Part of comment resolution documentation for Draft D3.1.

Date August 1, 2008.

Author: Yair Darshan / Microsemi Corporation

Revised Figure 33-14:

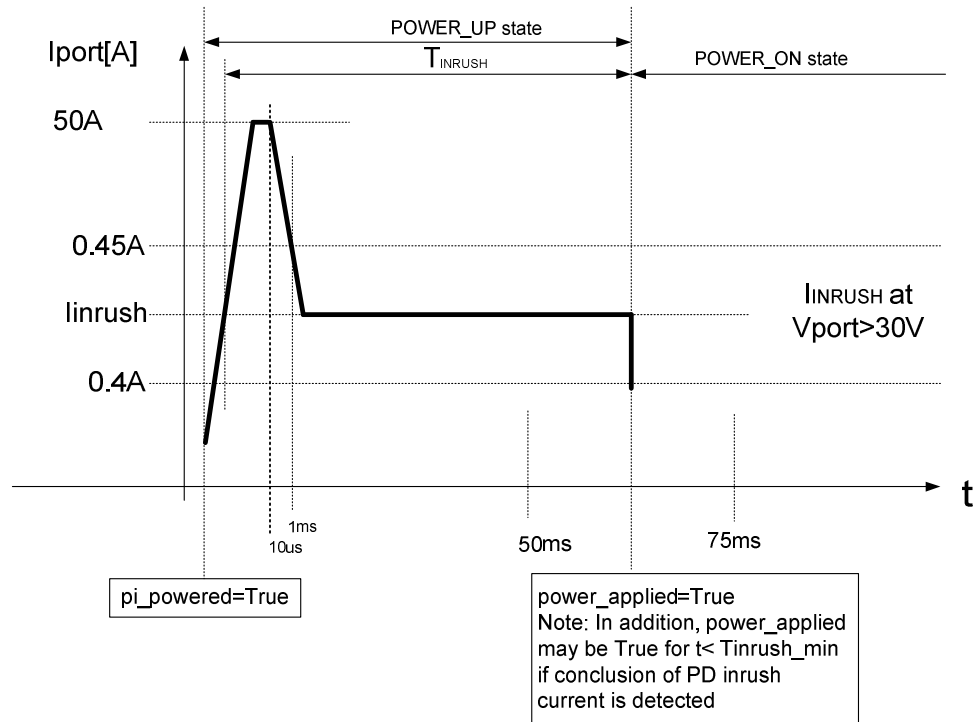
Few errors were corrected and additional information was added:

1. POWER\_ON state label was replaced with the correct one , POWER\_UP
2. Dash lines for Tinrush were synchronized with Iinrush
3. State machine variables added for clarification
